Form No. : SI202012-04

Change Type	<input checked="" type="checkbox"/> Material / Specification Change <input type="checkbox"/> Equipment Change <input type="checkbox"/> Process Change <input type="checkbox"/> Man Change				
Product Type	Speaker	Model No.	<b>SP-2014L-1</b>	Affected Date of the Change	4 Dec 2020
Reason for Change :					
Raw materials have been discontinued and have been replaced with new materials.					
Areas to be Changed					
Before Change :			After Change :		
1. Front			1. Front

3. Dimension			3. Dimension

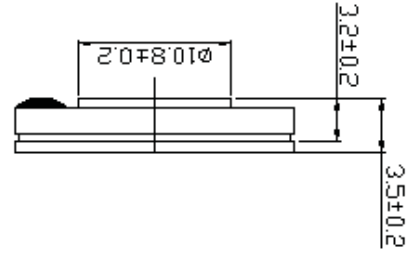
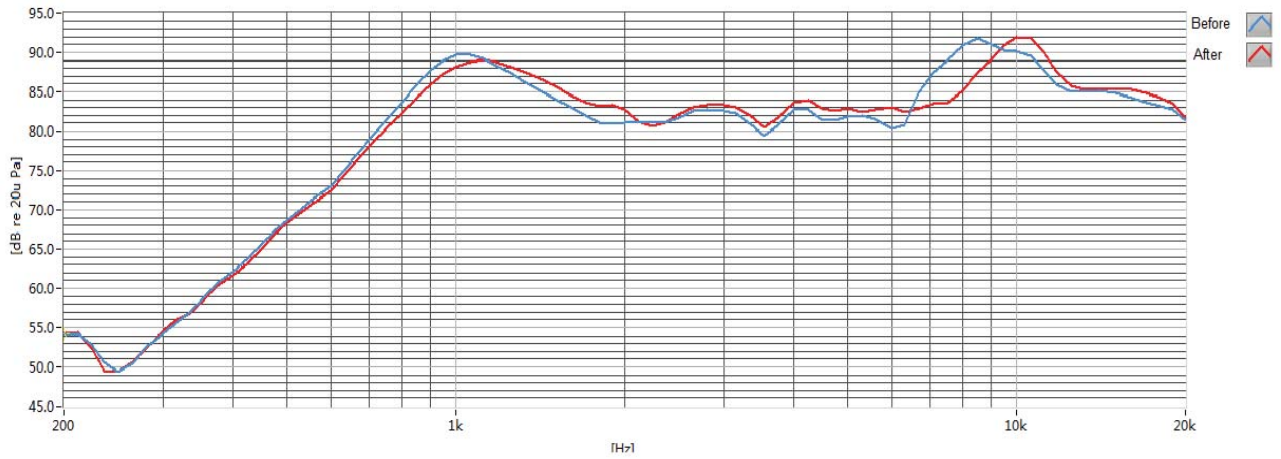
Electroacoustic characteristics: Impedance, Sound Pressure Level, Response Frequency, Power Rating, and Distortion are the same as before. Also, as there is only a nominal increase in size, 0.2mm, the change will not impact any area of functionality.
